City Council Questions February 26, 2019 Council Meeting

ITEM 3.1 701-747 WEST EVELYN AVENUE PARKING AND DESIGN

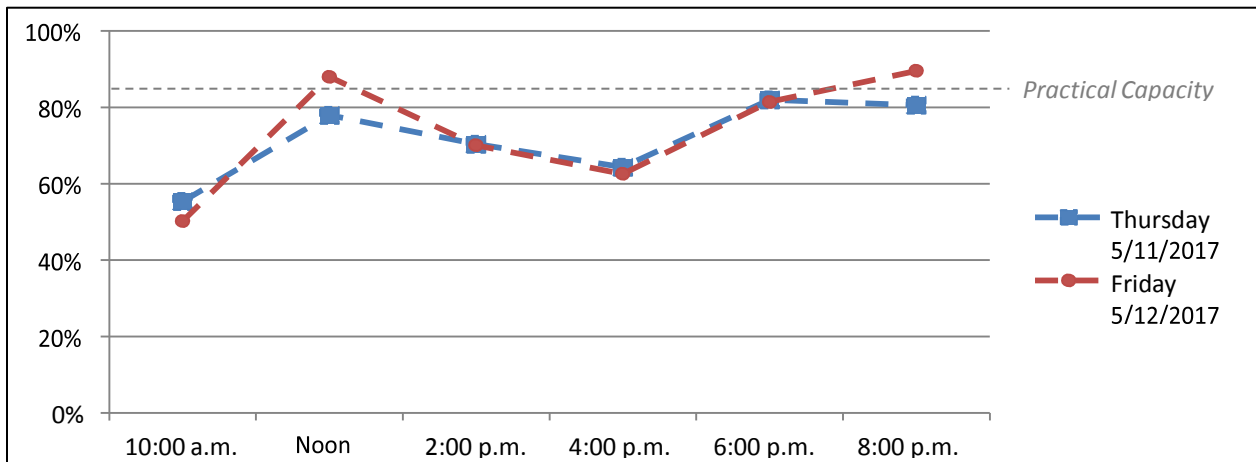
- Can we get Figure 1 on page 7 of the staff report for previous counts so we can see how/if demand has changed over the years?

Here are the data from May 2017, which were pulled from the September 2017 staff report. The April 2018 data are slightly higher than the points below. However, these are just two measurements, and may not accurately reflect an overall trend. Additional counts and trend information will be provided with the March 19 Study Session.
